REPORT TO THE PLAN COMMISSION

Site Plan

Project Name:	Matt Talbot Recovery Services, Inc. CBRF
Project Location:	9132 South 92 nd Street
Property Owner:	Shinken, Leo & Milton
Applicant:	Matt Talbot Recovery Services, Inc.
Agent:	Nathan Laurent, Keller, Inc.
Current Zoning:	R-3 Suburban/Estate Single-Family Residence District and C-1 Conservancy District
2025 Comprehensive Plan:	Areas of Natural Resource Features
Use of Surrounding Properties:	Single-family residential to the north, south and west and vacant land zoned B-2 District to the east
Applicant's Action Requested:	Approval of Site Plan Application for the construction of a 5 bedroom CBRF development

A RESOLUTION APPROVING A SITE PLAN FOR A 5 TO 8 BEDROOM STATE
LICENSED COMMUNITY BASED RESIDENTIAL FACILITY DEVELOPMENT
(9132 SOUTH 92ND STREET)
(MATT TALBOT RECOVERY SERVICES, INC., APPLICANT)

SITE PHOTOMETRIC LIGHTING PLAN

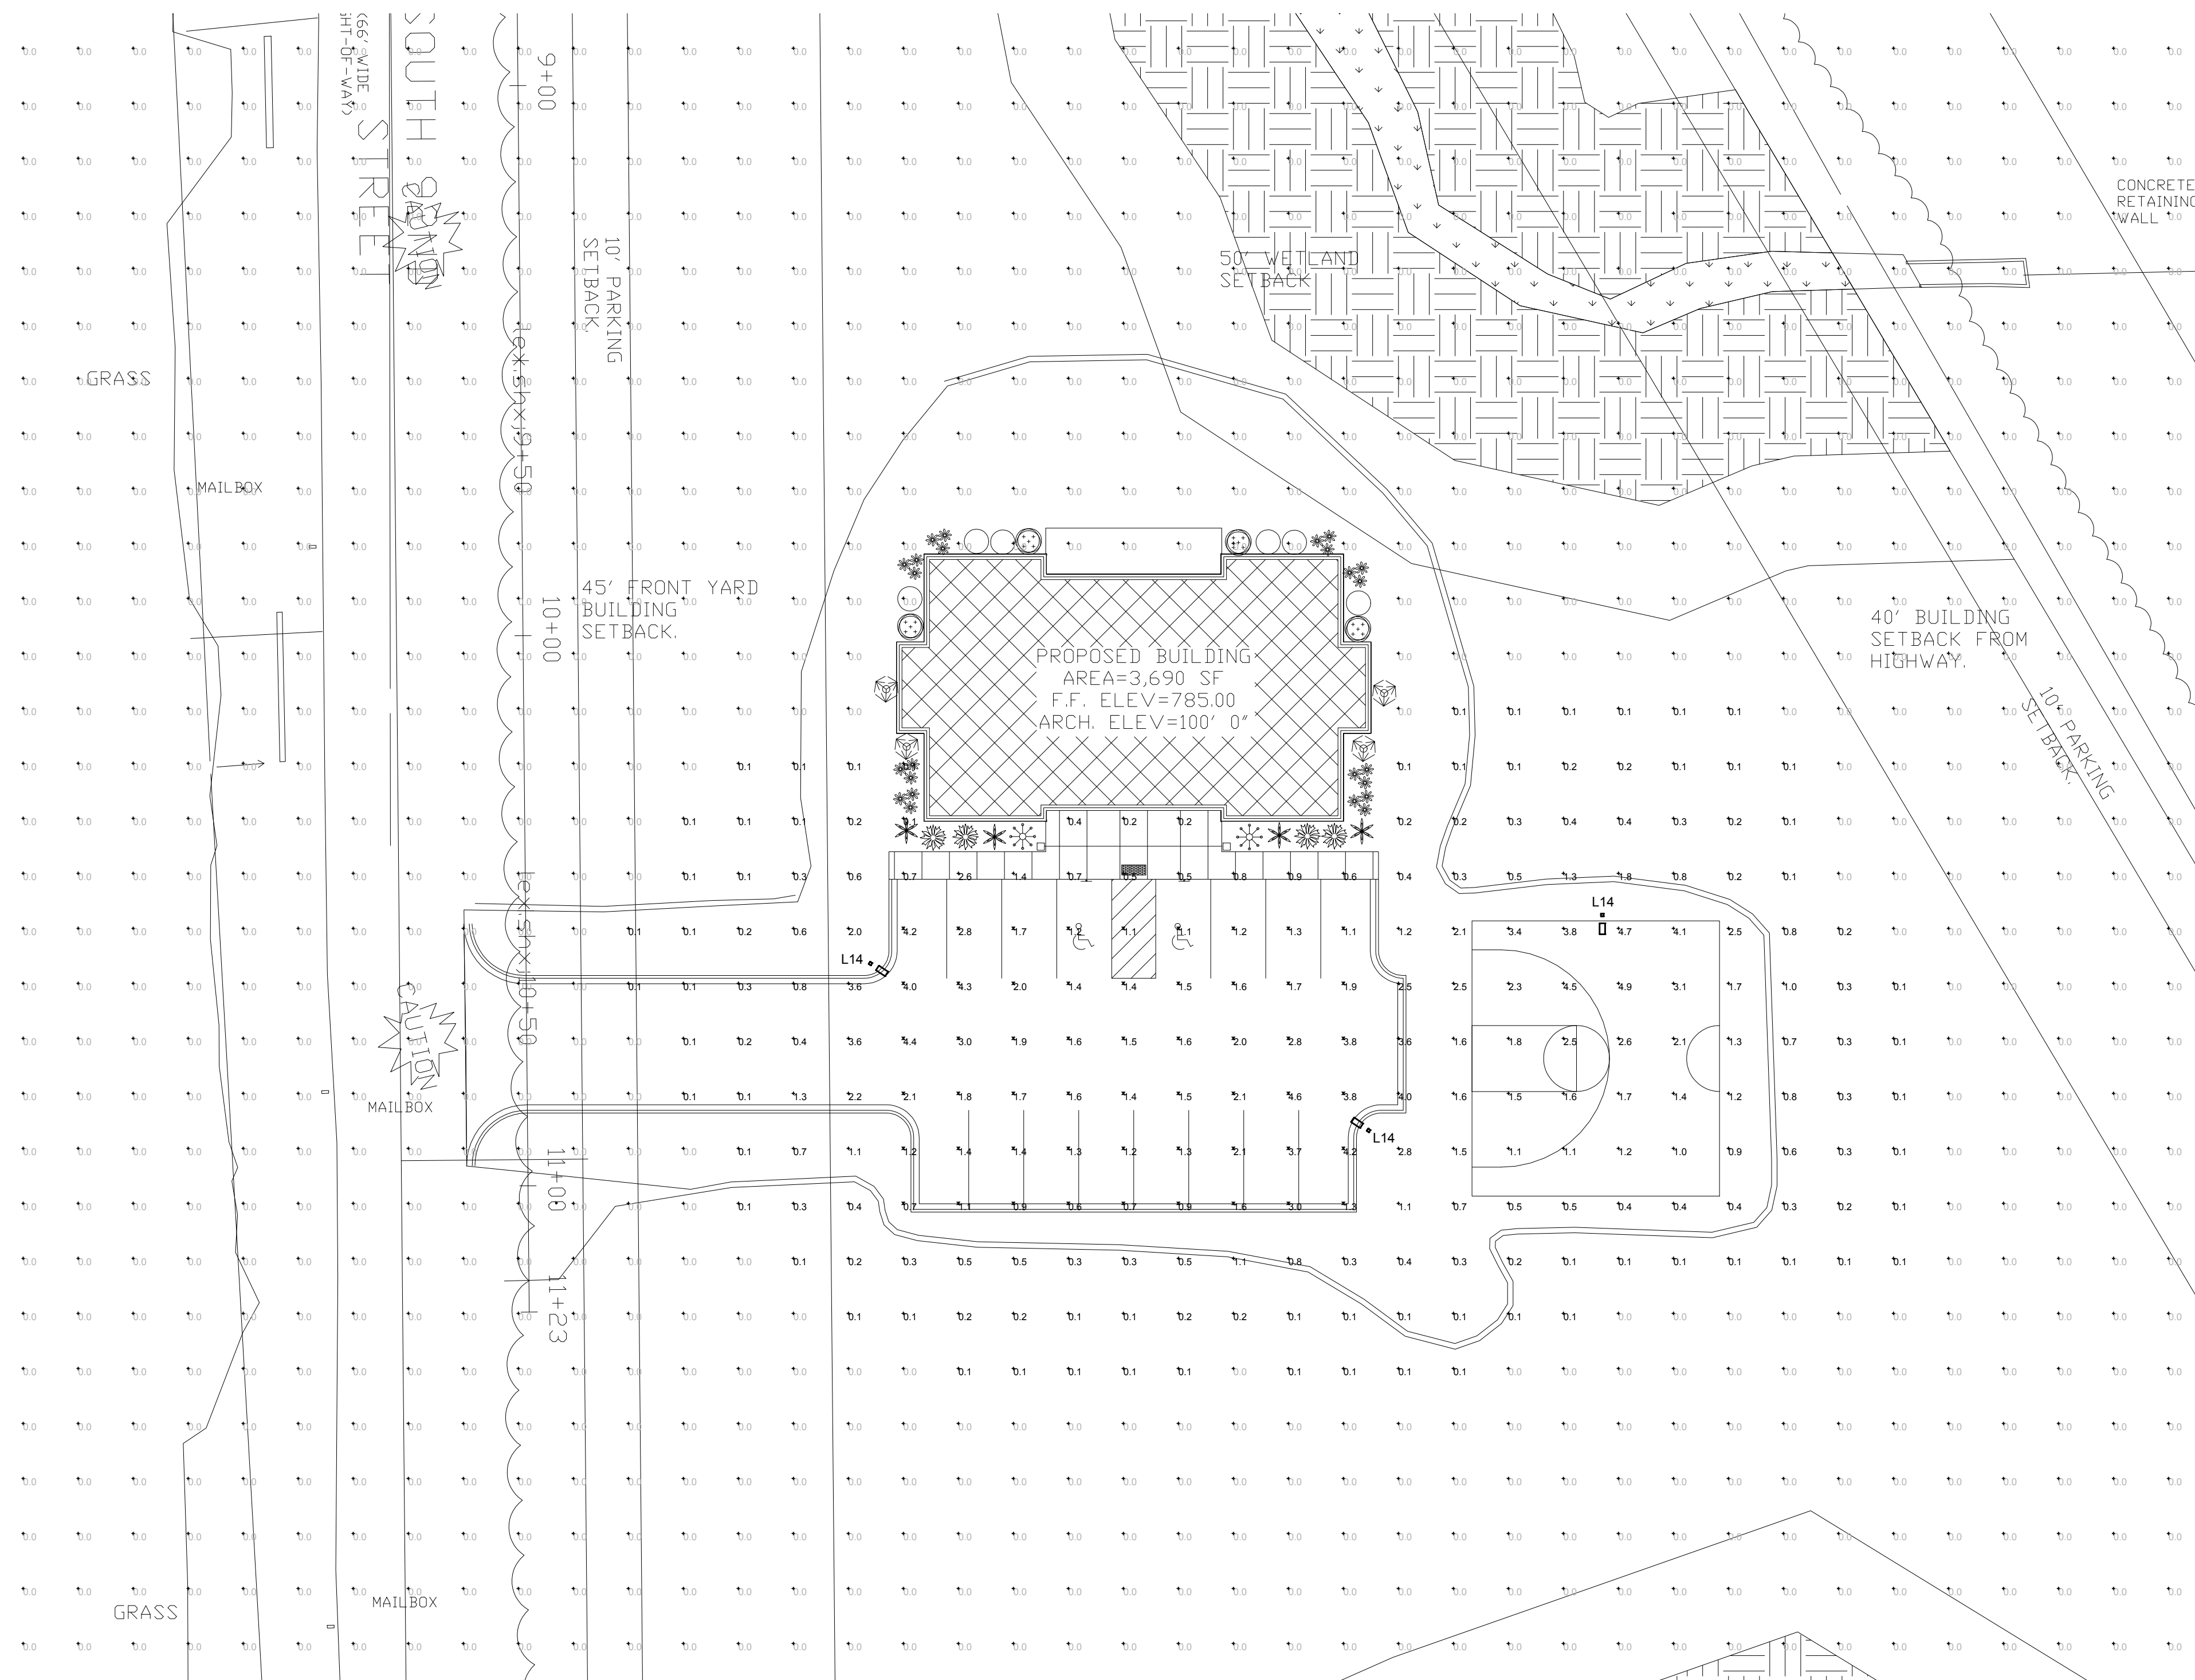
The applicant is proposing three pole lights. Two pole lights are located near the northwest and southeast corners of the parking lot. The third light pole is located on the north side of the basketball court. The lights have an overall height of 15-feet. The photometric plan is in conformance with UDO lighting standards.
